# Staff Summary Report

**SUBJECT:** Hold a public hearing for a Use Permit and Development Plan Review for SELF-SERVE CAR WASH located at 1336 West University Drive.

**COMMENTS:** Request for **SELF-SERVE CAR WASH (PL060720)** (Kay Hamblin, property owner; John Reddell Architects, applicant) for the redevelopment of an existing car wash into a new car wash totaling 3,191 s.f. in building area, located at 1336 West University Drive, in the CSS, Commercial Shopping and Service District, including the following:

**DPR06134** – Development Plan Review including site plan, building elevations and landscape plan

FLOOR PLAN

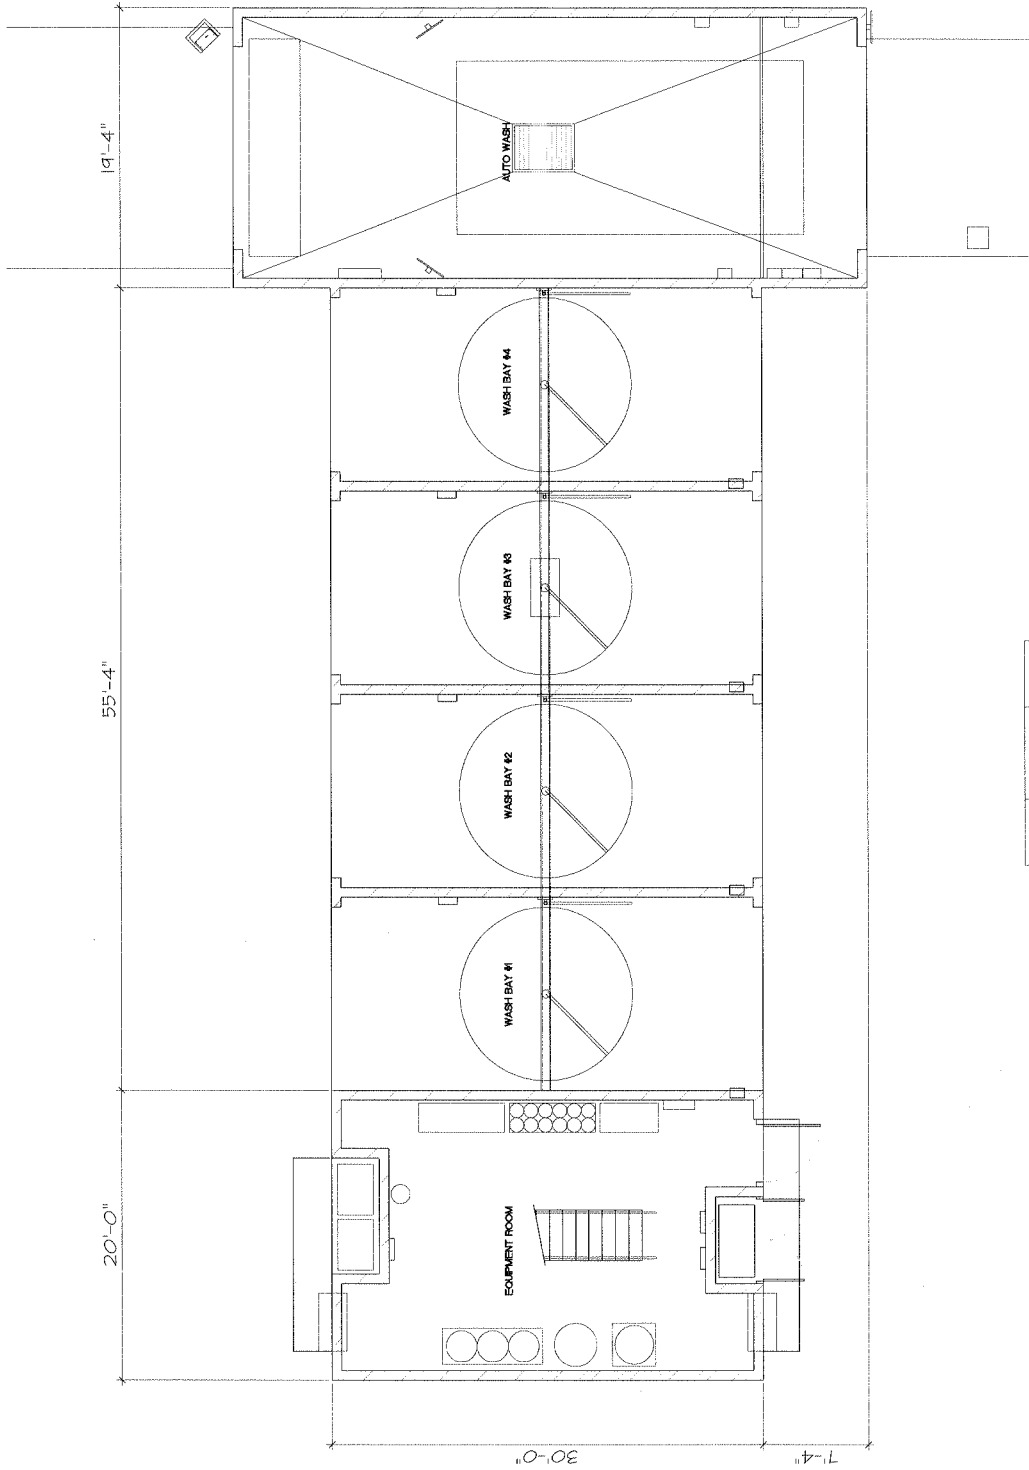
15. Vending machines integrated into the building shall provide secured fencing to prevent vandalism.

# **FULLY ENCLOSED VACUUM PEDESTAL SECTION**

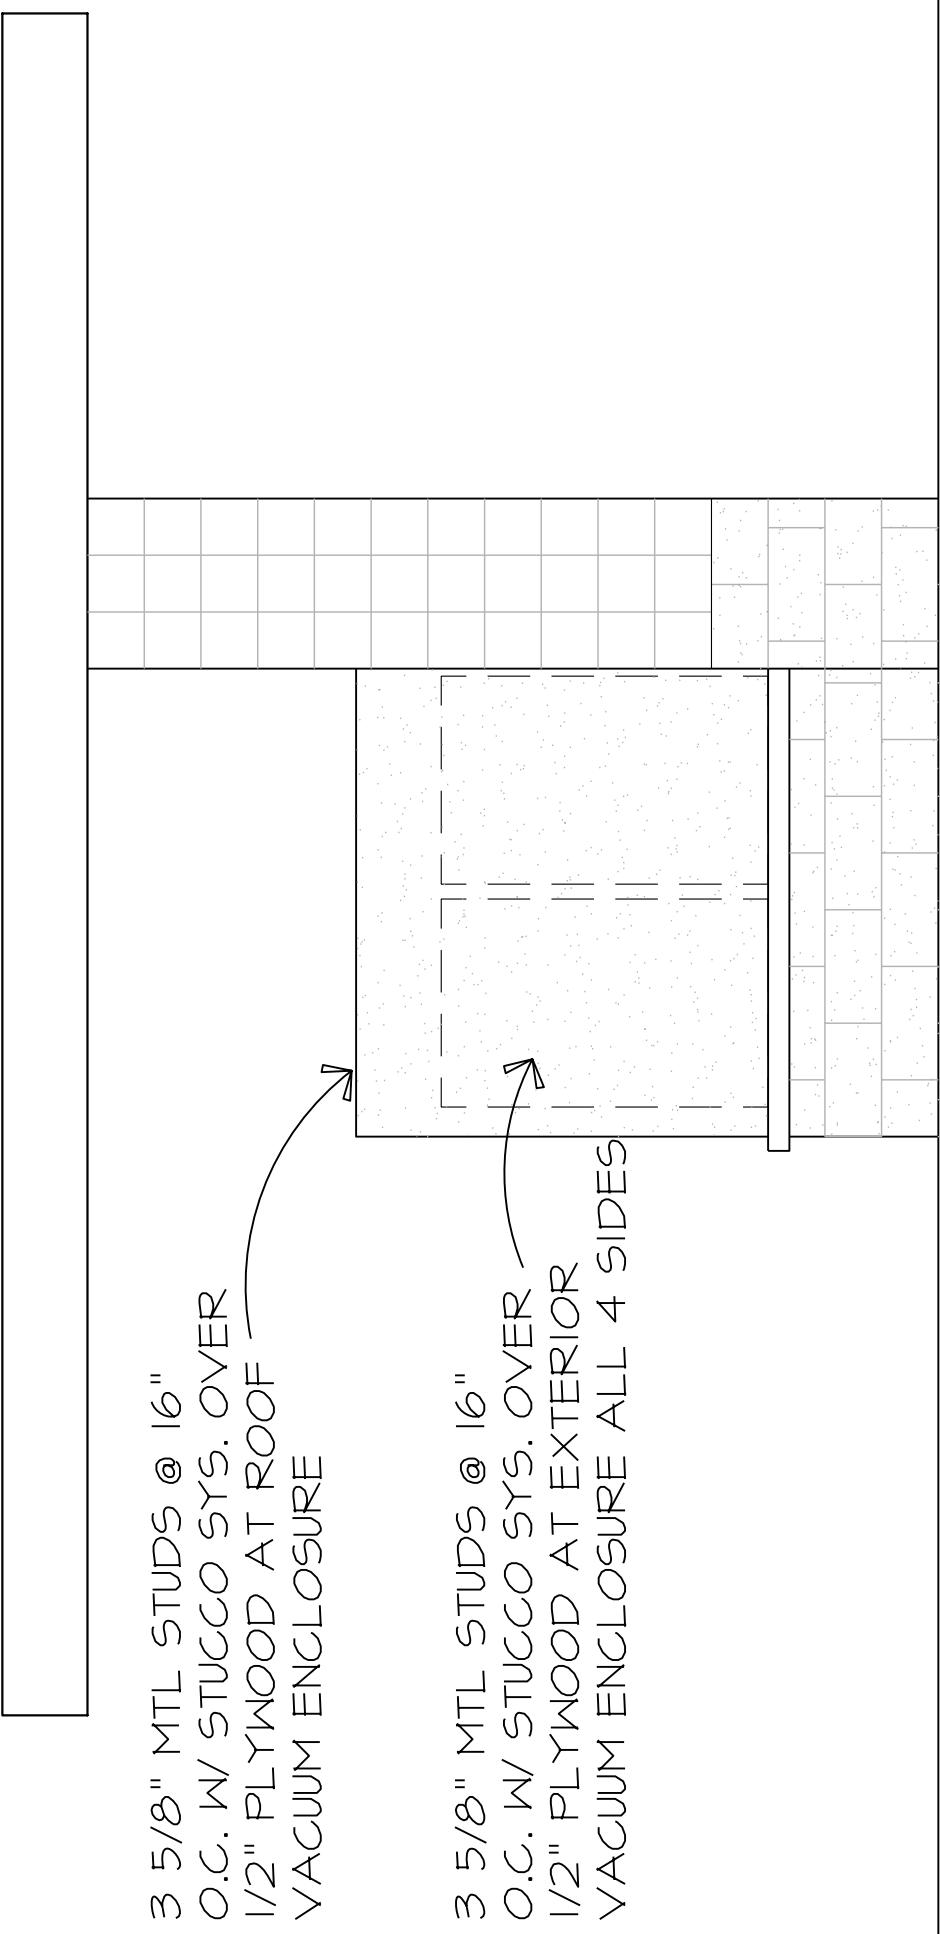
8. **The vacuum units shall be enclosed within an additional sound dampening component to reduce noise levels. (ADDED BY STAFF)**
- The project site does not have an Archaeologically Sensitive designation. However, State and federal laws apply to the discovery of features or artifacts during site excavation (typically, the discovery of human or associated funerary remains). Where such a discovery is made, contact the Arizona State Historical Museum (520-621-6302) for removal and repatriation of the items. Contact the Tempe Historic Preservation Officer (Joe Nucci 480-350-8870) if questions regarding the process described in this condition.
